# PD Modification Application: PRS 25-0665

## 1.0 APPLICATION SUMMARY

The applicant is seeking a Minor Modification to allow a wireless communication facility as permissible in the northeastern corner of the parcel in Parcel A-1. If approved, a Conditional Use Permit will be necessary.

### **8.2 Proposed Site Plan (Full)**

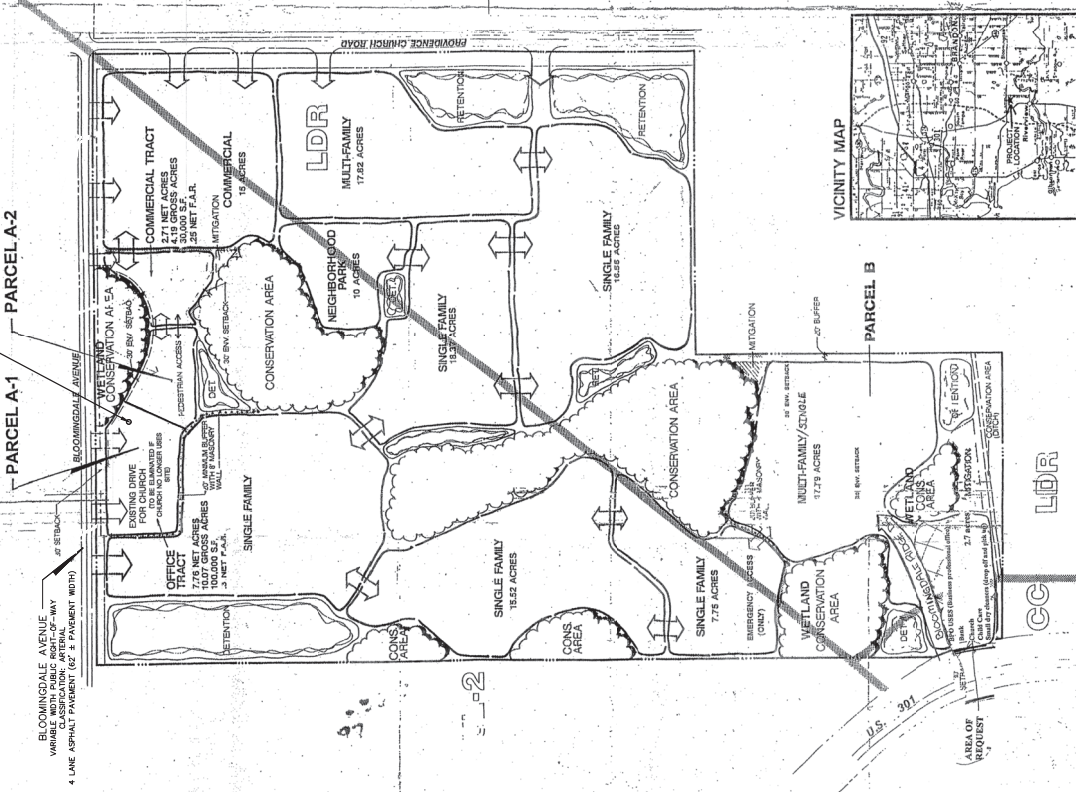
NOTE: WIRELESS COMMUNICATION  
SUPPORT STRUCTURE A-1 IS  
CONCEPTUAL AND SUBJECT TO  
RELOCATION IN ACCORDANCE WITH  
CONDITIONS OF APPROVAL

WIRELESS COMMUNICATION SUPPORT STRUCTURE FACILITY  
PARCEL A-2
